20/02101/FUL: A residential led development consisting of 48 flats over 2 buildings with a commercial unit at ground floor at 229 Willowbrae Road, Edinburgh

229 WILLOWBRAE ROAD, EDINBURGH
Application Reference No: 20/02101/FUL

A Response to CEC Planning Department
and Statutory Consultees

A residential led development consisting of 48 apartments over 2 apartment buildings with a commercial unit at ground floor.

BIN AND BIKE STORES RECONSIDERED TO IMPROVE REFUSE COLLECTION ARRANGEMENTS IN RESPECT TO PULL DISTANCES AND ISSUES RAISED BY THE ROADS DEPARTMENT

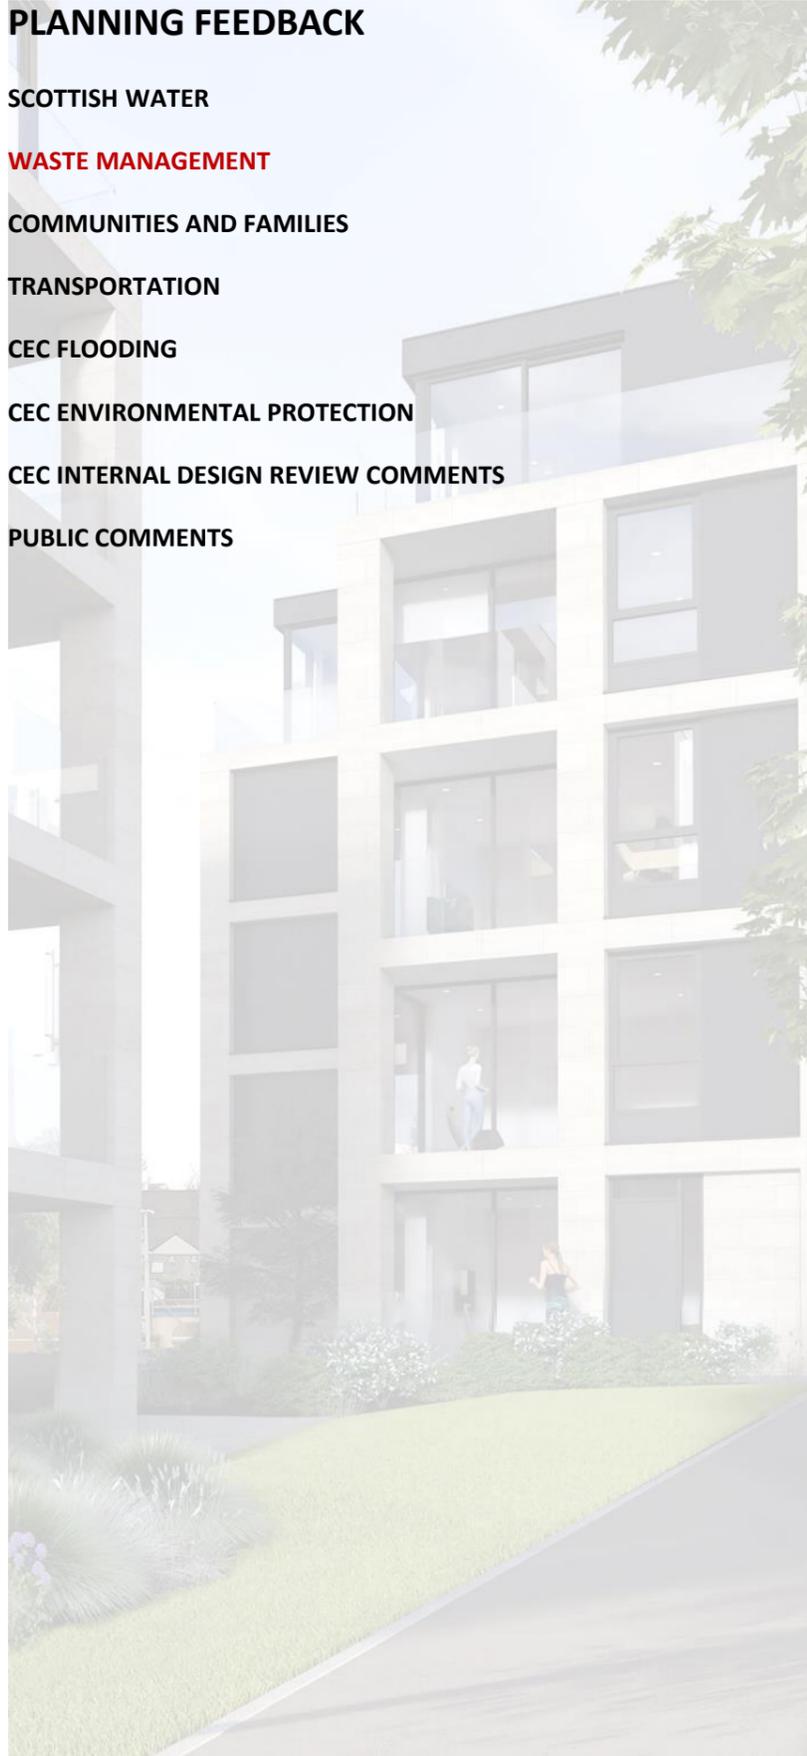
*I have looked at the drawings available in the planning portal file, we would require further input to the points raised below in conjunction with our current **instruction for architects and developers** guidance (attached) to ensure waste and recycling requirements have been fully considered.*

- 1. I would require some alterations to the pull directions.*
- 2. A detailed plan showing dimensions and bins in place along with*
- 3. Confirmation of the number of flats using each bin store.*

An agreement in principle has been reached with the CEC Waste Services following detailed discussions with the following measures made / agreed:

1. The bin stores have been combined together (as shown on the following page) and access to the bin store improved to reduce the pull distances to a distance that the waste services are satisfied.
2. The ground floor plan was amended and the plan developed to detail the bin store arrangement.
3. It was confirmed that 48 apartments would use this bin store.

The drawings on the following pages show the amended proposals as they were developed following dialogue with CEC Waste Services. The changes as agreed will be incorporated into an updated set of floor layouts and site plans.
